Bramford to Twinstead Reinforcement

**Document 8.9.5 (C): Temporary and Permanent Access Technical Note
– Suffolk County Council**

**Final Issue C
February 2024**

Drawing title
**D-AP1: Layham
 Proposed Visibility Splay
 Concept Design
 Sheet 1 of 1**

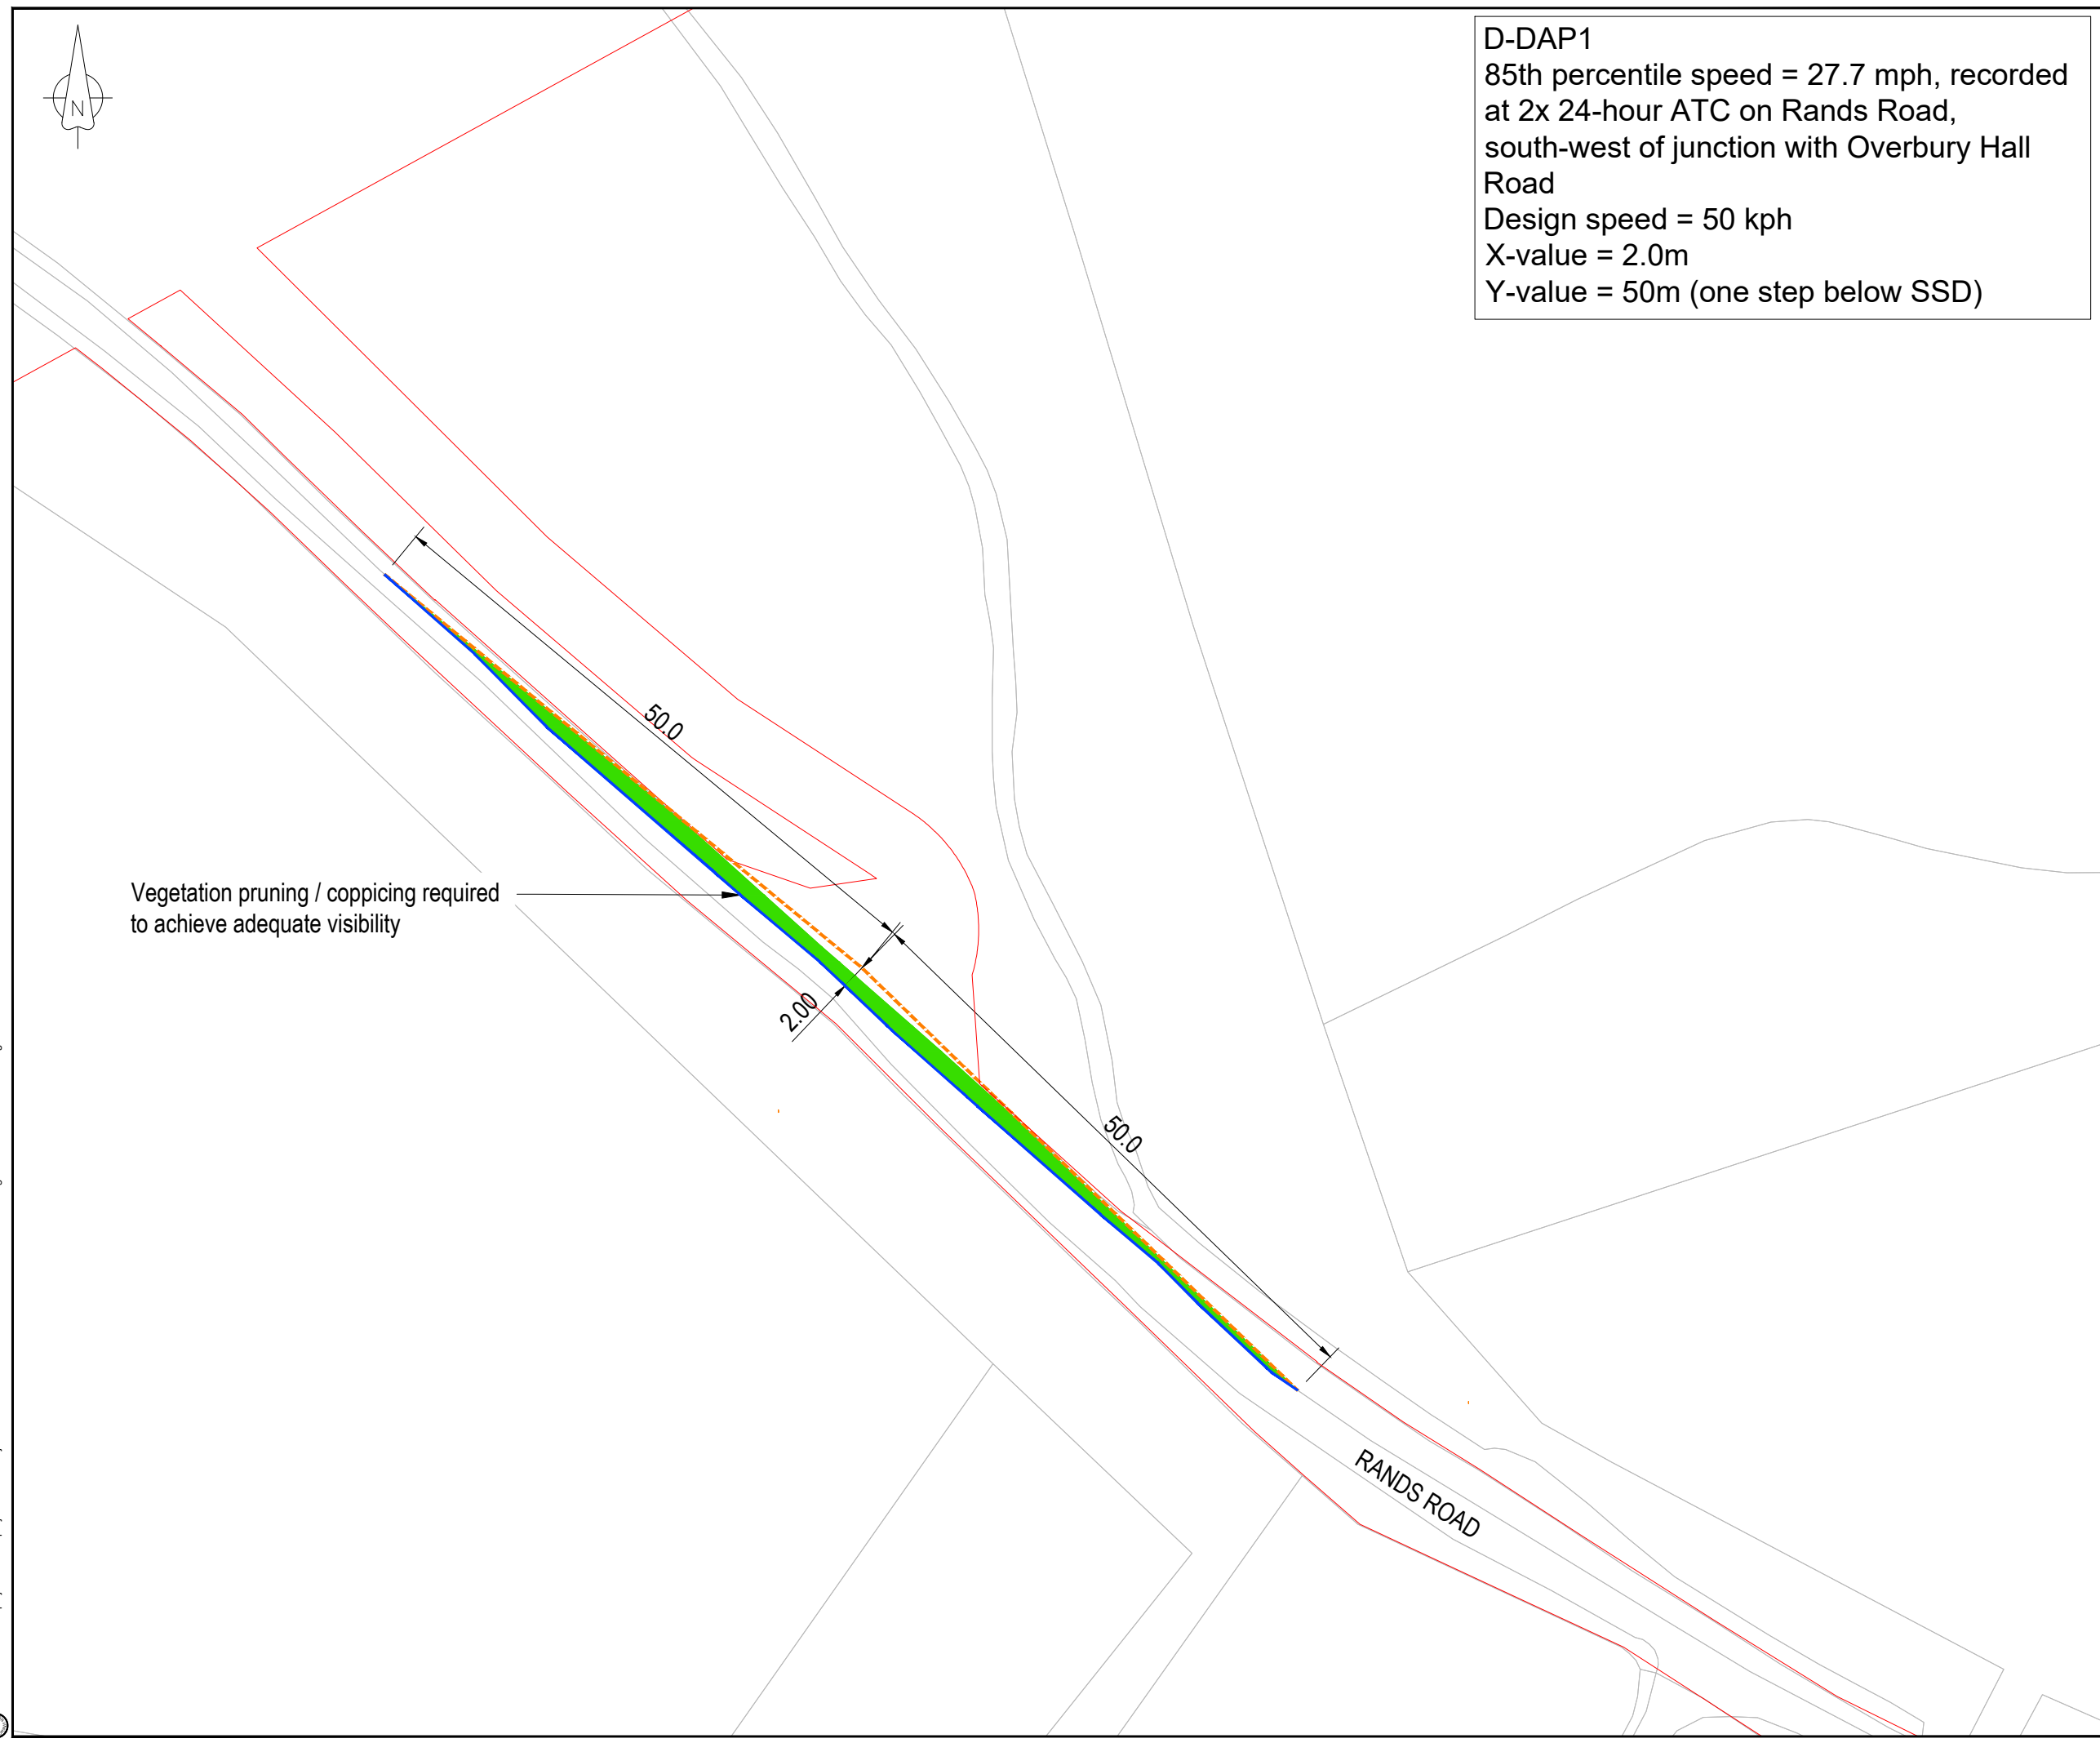
2.6.1 D-AP1 (Overbury Hall Road, Layham) is shown on sheet 11 of 30 on the Access Rights of Way and Public Rights of Navigation Plans [APP-012] and in Appendix A of this Technical Note. This provides access to a number of pylons between Overbury Hall Road and Rands Road. Access would be provided via an existing field access west of Overbury Hall Road As shown on the Construction Routes contained within Appendix A of the Construction Traffic Management Plan [REP6-025], access via D-AP1 would solely be from the south.

- 2.6.7 As for other accesses discussed, a solution has been discussed that would mean this access is deliverable and further detail would be provided with information to discharge Requirement 11.

Drawing title: **D-DAP1: Rands Road, Layham Proposed Visibility Splay Concept Design Sheet 1 of 1**

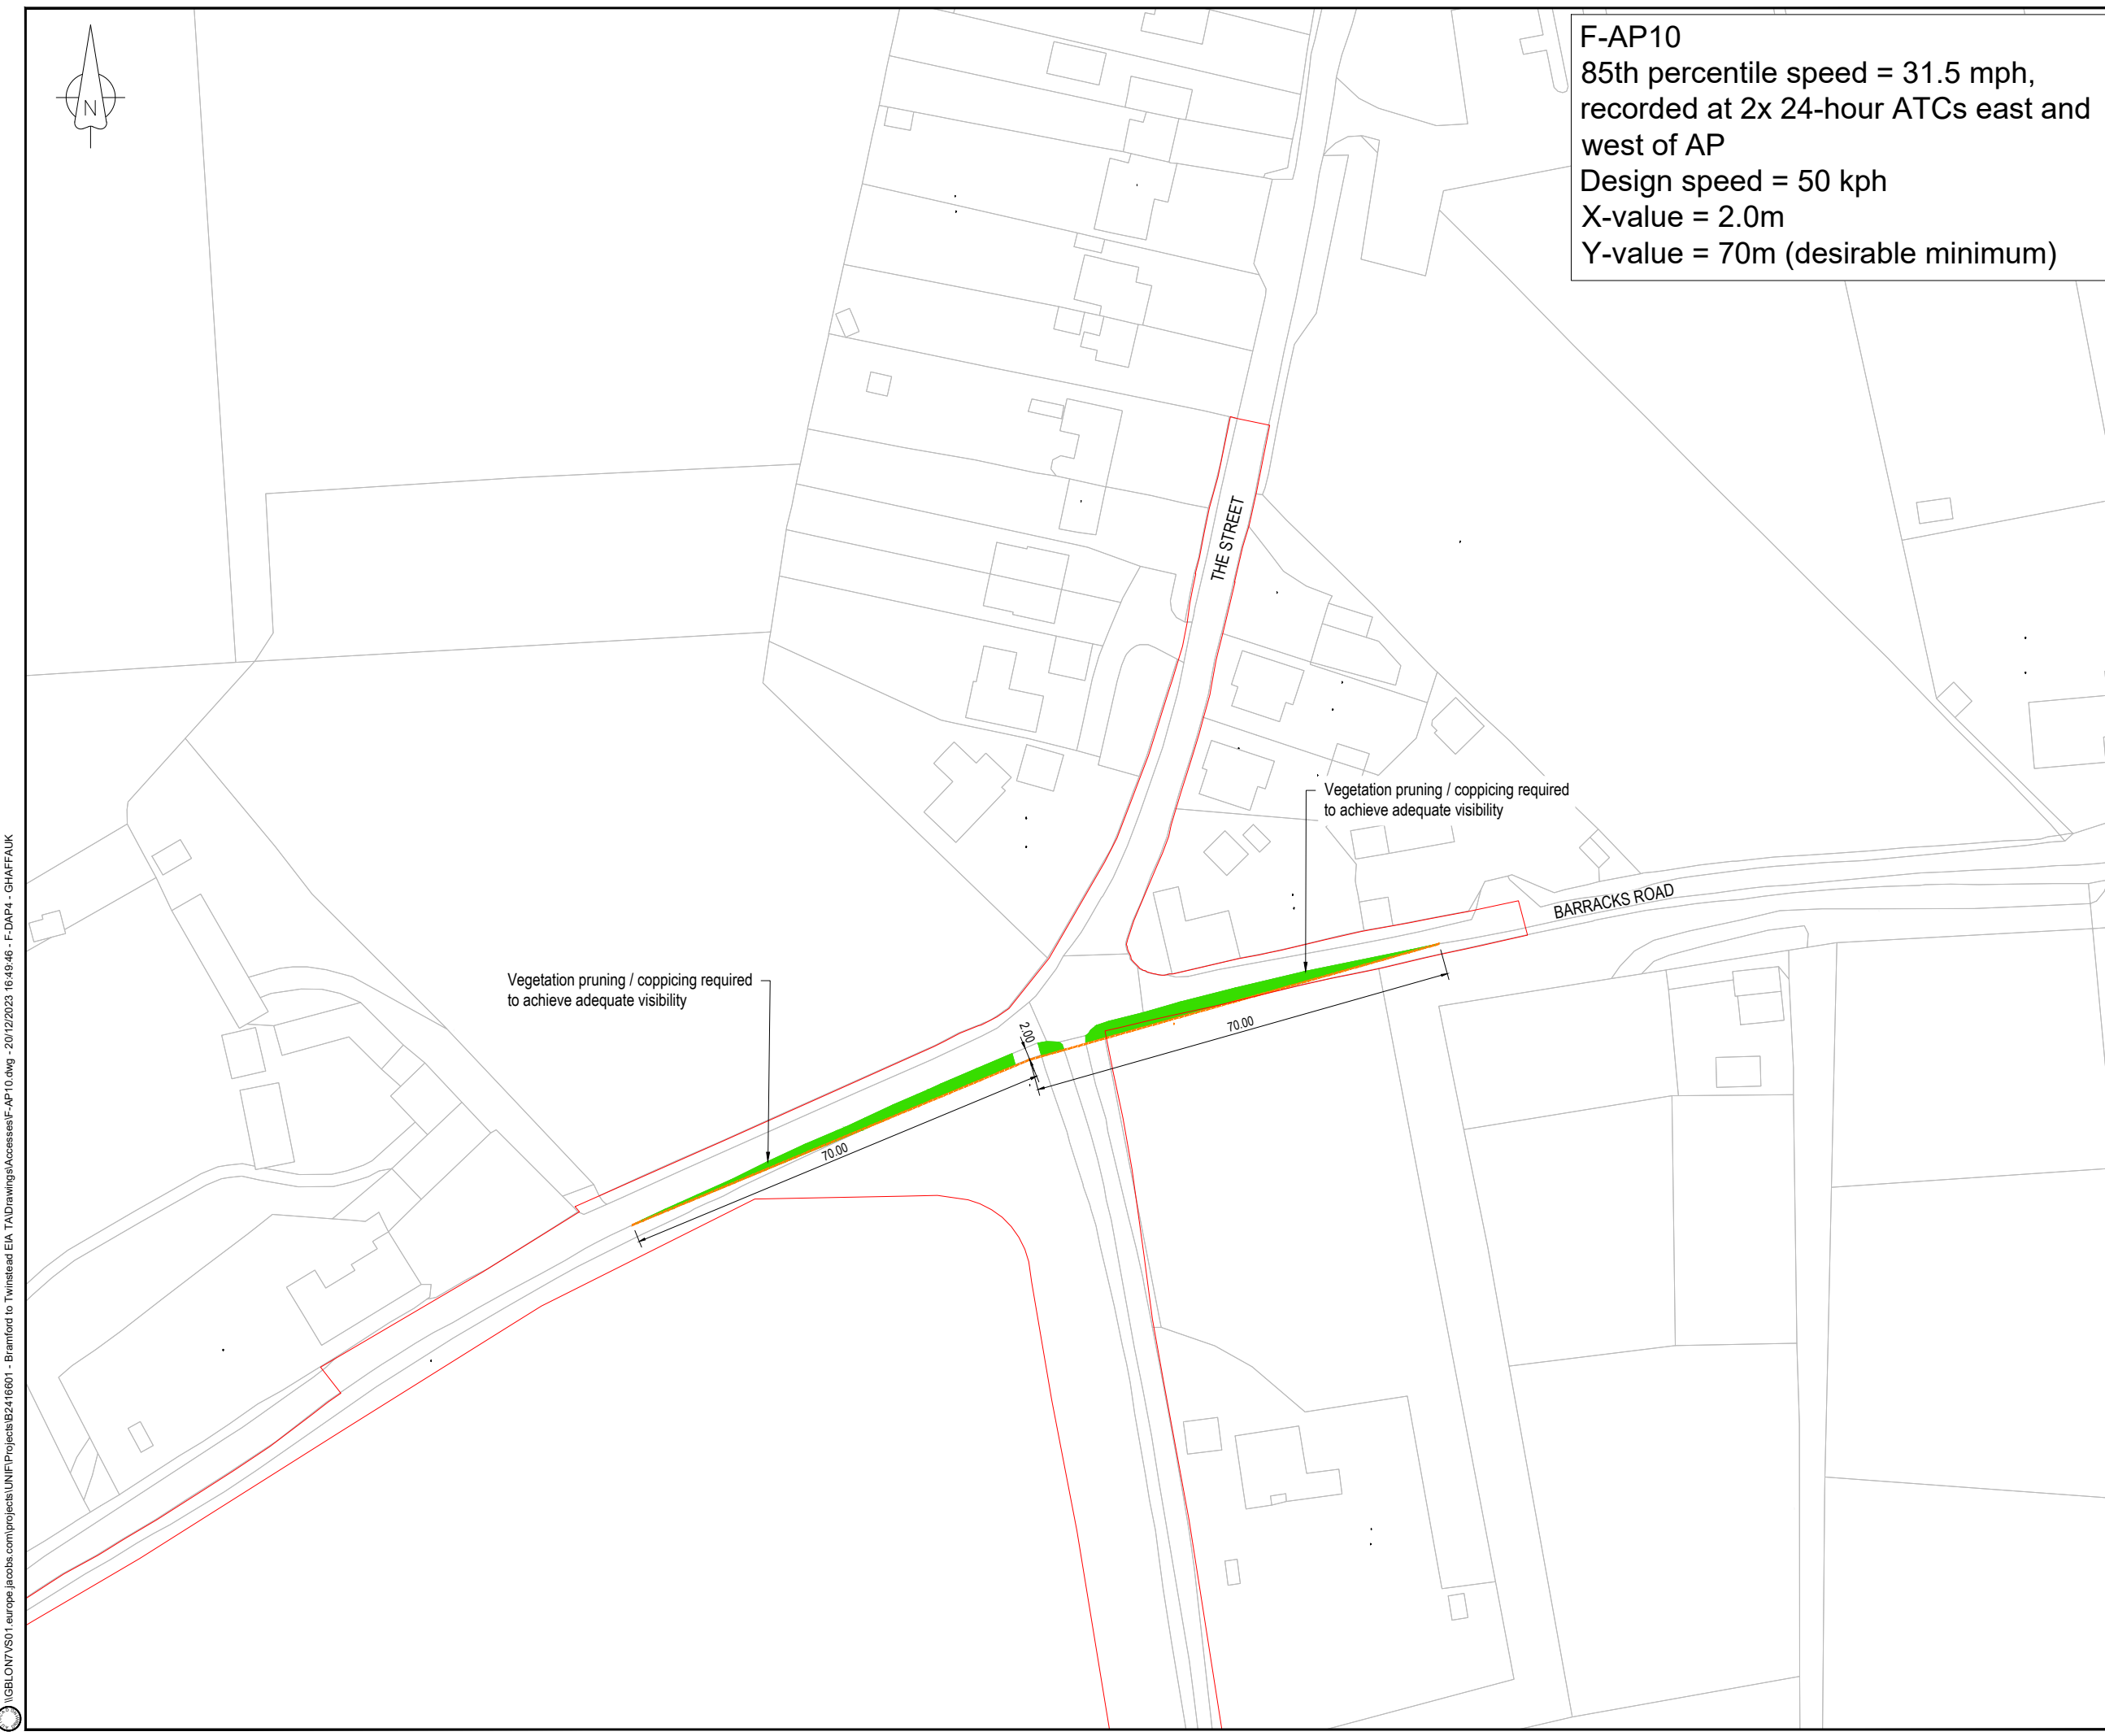
- 2.7.6 The combination of these aspects means that this access, which is only required for removal of the 132kV line, could have excessive impact on vegetation. Therefore, given the single track width and small scale nature of the work (primarily unloading plant/materials and loading removed apparatus), it may be appropriate to use a short-duration closure to create a more modest area of vegetation removal on a road-field boundary as an access to the adjacent farmland. This would be explored during the

detailed design stage, but discussions confirmed that solutions were available. These noted that traffic management measures are likely to provide a more proportionate approach for this lightly-used access, to avoid excessive vegetation removal to provide the full visibility splay.
